**project.** Sherwood Library Renovation | 1225 Wonderland Rd N, London, ON

**project no.** 23-006

This Addendum is issued before the award of Contract to inform the Contractor of certain modifications to the work described in the Drawings and Specifications dated September 18, 2024.

end of addendum | 001

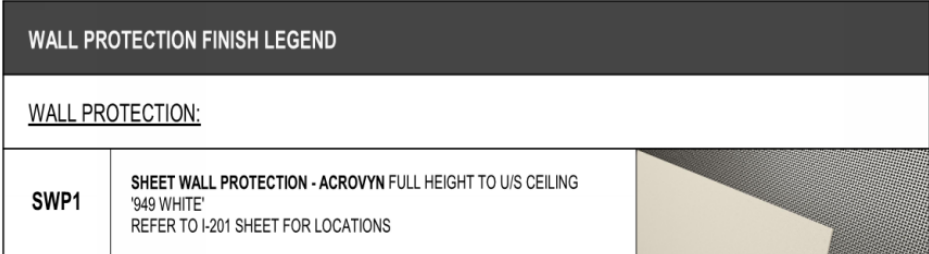
1.3 **Question:** Could you please describe what "Identified Pricing - 1 and 2" required on bids&tenders is for?

**RESPONSE:** "Identified Pricing – 1 and 2" are required for cost sharing between the London Public Library and the Mall Owner. This scope includes all work from floor to underside of structure in the identified areas.

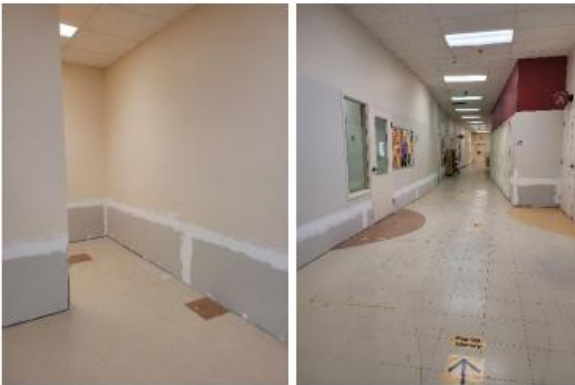
<p>1.8</p>	<p><b>Question:</b> Are existing remaining walls impacted by the flood required to be repaired in this contract?</p> <p><b>RESPONSE:</b> The scope that will be required to be covered by the successful contractor includes:</p> <ul style="list-style-type: none"> <li>• All Existing walls to remain shall be repaired where drywall is missing (section at base of wall, see photos below). This includes all areas belonging to the library.</li> </ul>

- Existing walls to remain that have been taped and mudded will require sanding, finishing and painting (see photos below). This includes all areas belonging to the library.

New drywall work required, typ.

Existing drywall finishing required.

A230

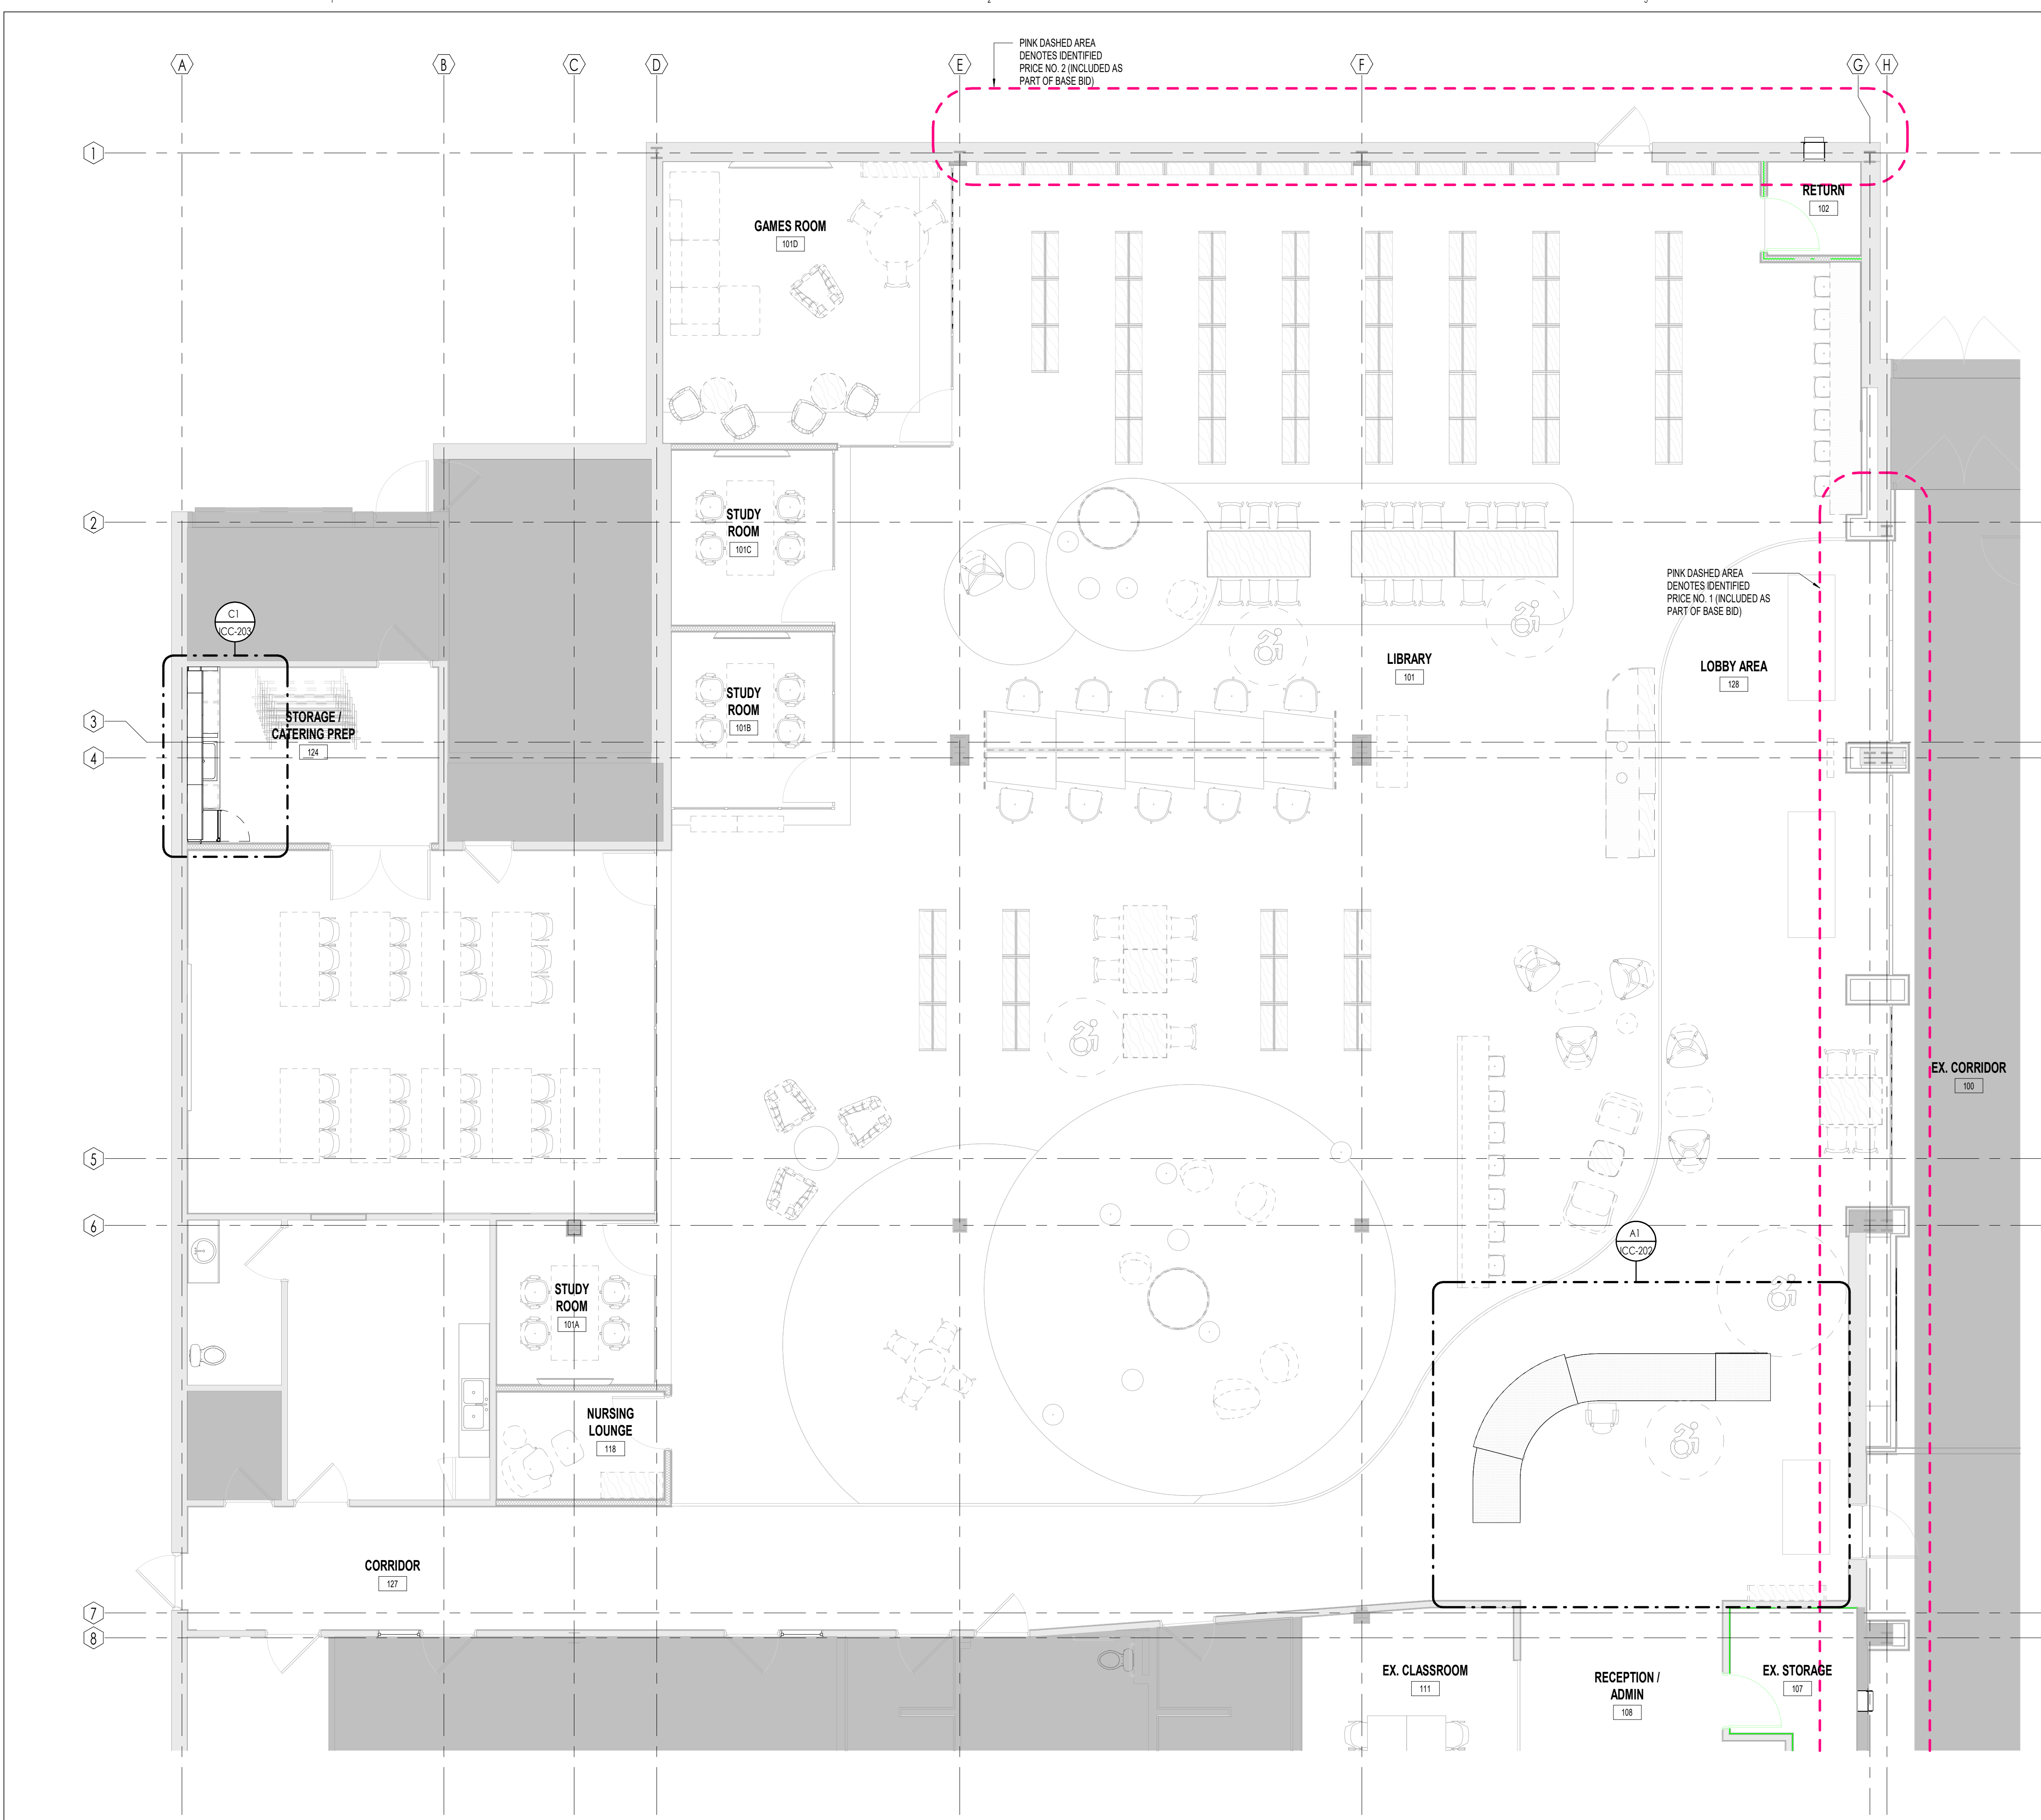
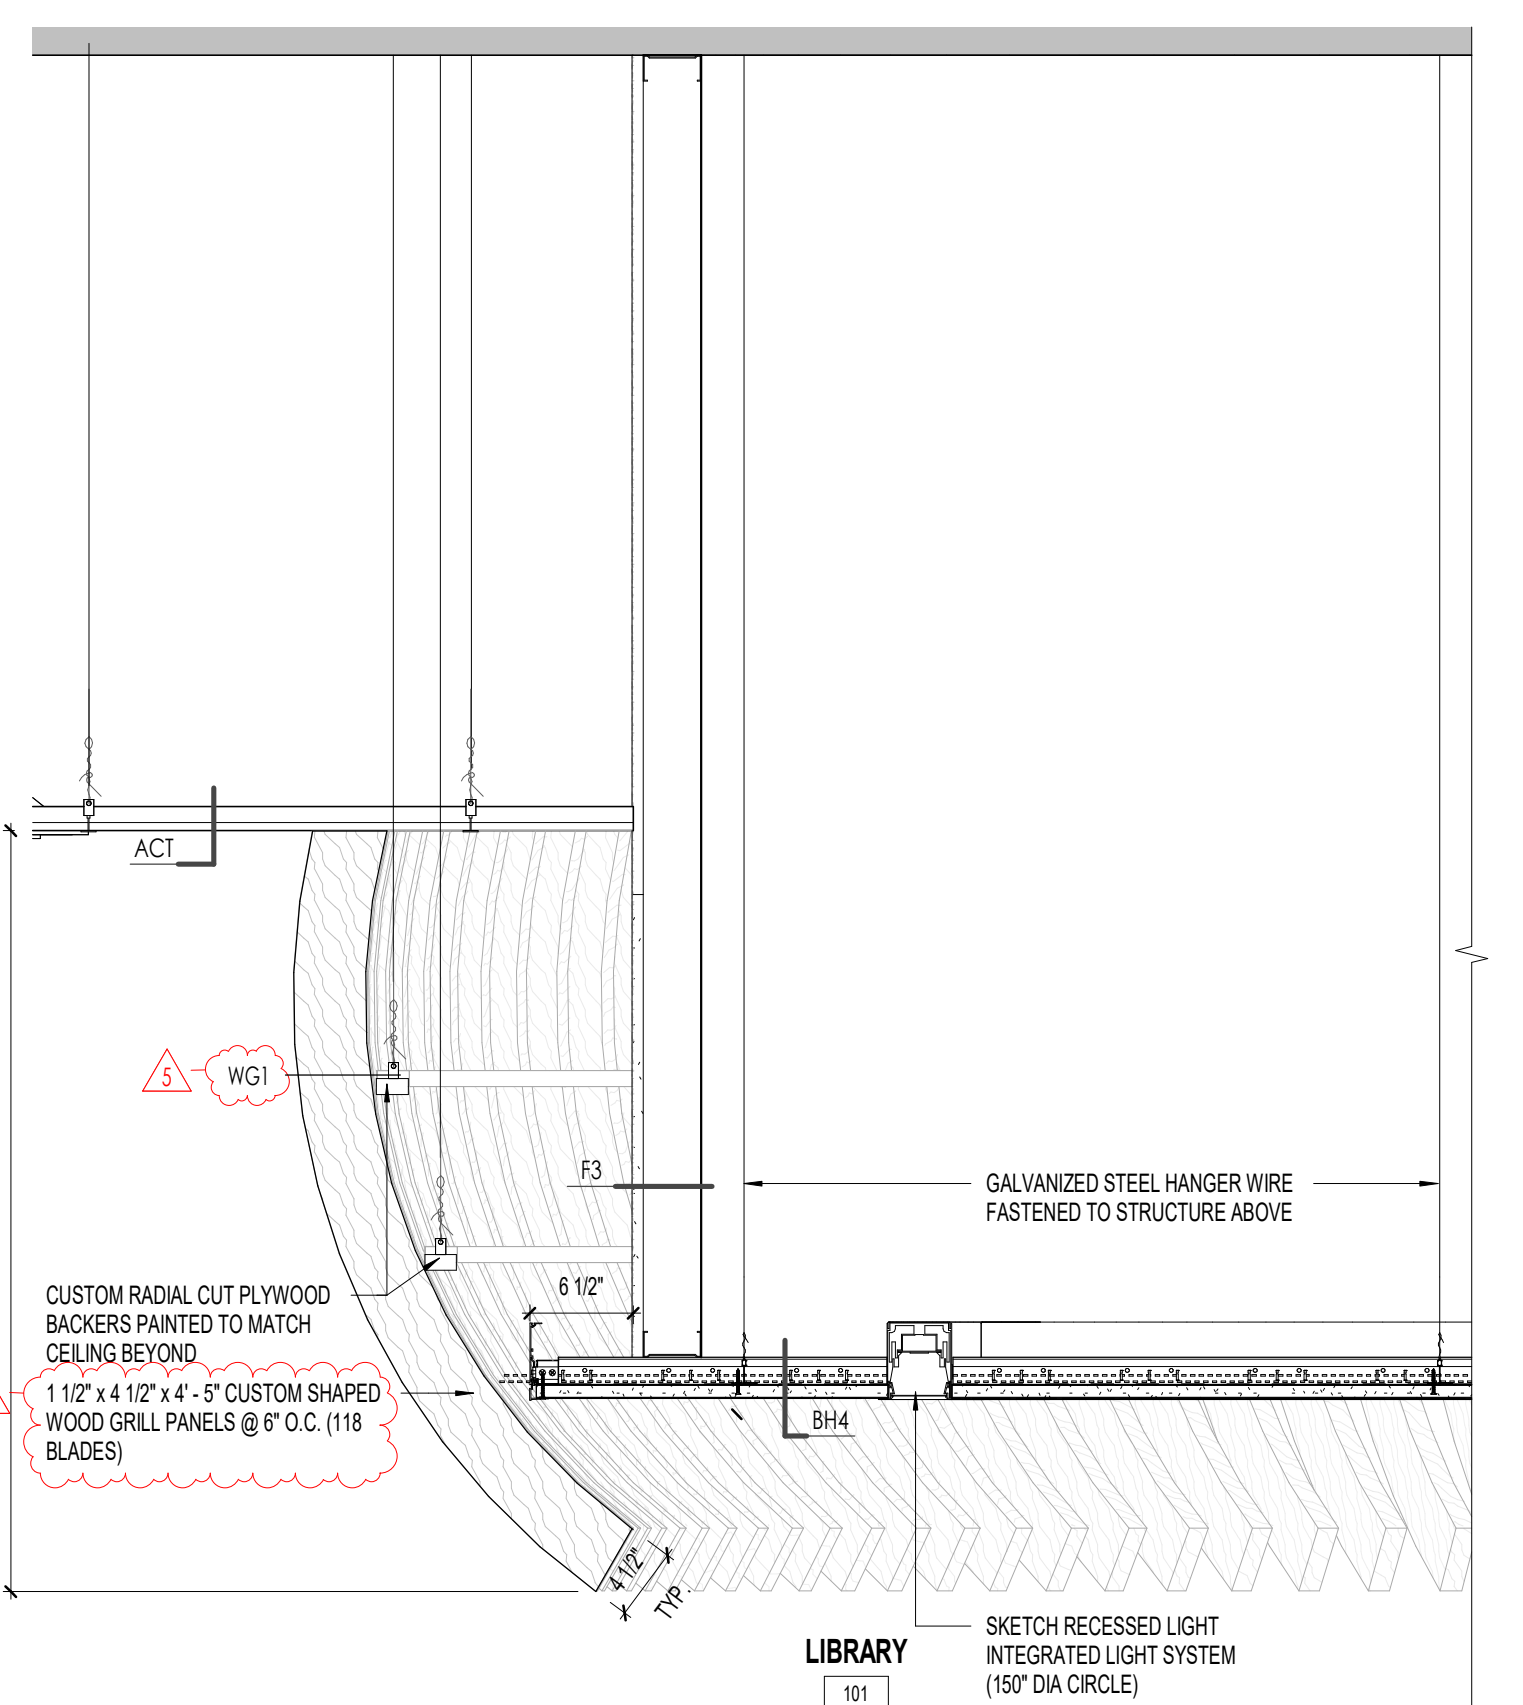
item no.	REFER TO DESCRIPTION
1	<b>Contractor/Sub-Trade Questions (Received by 2024.10.02)</b>
<b>CEILING QUESTIONS:</b>	
1.1	<p><b>Question:</b> A230 Ceiling Design- Will there be a product spec or preferred vendor for purchase?</p> <p><b>RESPONSE:</b> The ceilings on architectural sheet A230 are an Armstrong product composed of AcoustiBuilt suspended ceiling systems (BH4) and Wood Grille Backer ceiling system (WG1). Please see attached Specifications for these ceiling systems. Updated sheet A320 has been included for clarification on the verbiage pertaining to these systems.</p>

<b>3</b>	<b>Architectural Drawings (Addendum 001) dated 2024.10.02 (4 pages)   have regard to revisions and/or clarification to the following drawings</b>
3.1	<p>A-230 CEILING DETAILS</p> <p>Refer to attached revised A320.</p> <p><b>Revise verbiage for WG1 system, including wood grille panels.</b></p>
3.2	<p>ICC-200 MILLWORK KEY PLAN - NORTH</p> <p>Refer to attached revised ICC-200.</p> <p><b>Revise MILLWORK FINISH LEGEND and remove:</b></p> <ul style="list-style-type: none"> <li>• <b>Plam 3, Plam 4, Plam 5</b></li> <li>• <b>UP1, UP2, UP3, UP4, UP5, UP6</b></li> </ul>
3.3	ICC-200 MILLWORK KEY PLAN - SOUTH
